**SUBJECT: NEW VEHICLE DEMONSTRATION / DELIVERY HOLD -
Safety Recall 24S32**
Certain 2024 Model Year F-150 Vehicles
Steering Column Lower Shaft Bolt Replacement

CERTAIN 2024 MODEL YEAR F-150 VEHICLES — STEERING COLUMN LOWER SHAFT BOLT REPLACEMENT

FIGURE 1

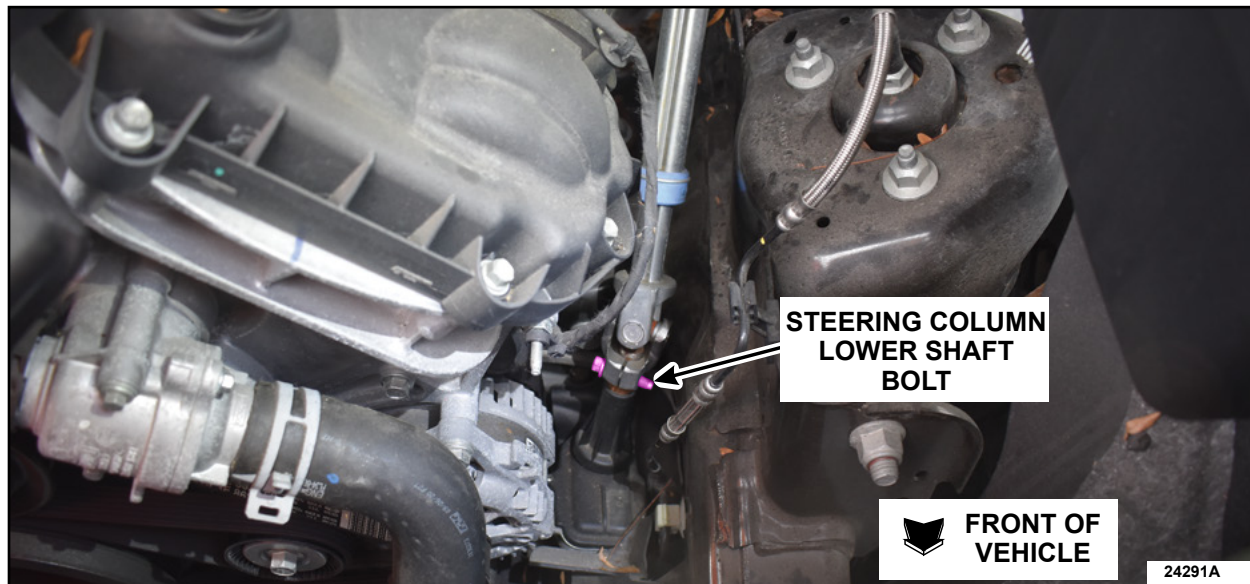
In the affected vehicles, it's possible that an incorrect fastener was used to secure the steering column lower shaft to the steering gear. The incorrect fastener may loosen over time and could disengage. If the fastener disengages, separation of steering system adjoining components may occur, resulting in loss of steering control, which can increase the risk of a crash.

1. Replace the steering column lower shaft bolt. See Figure 1. This completes the FSA.

- Torque: 22 lb.ft (30 Nm)
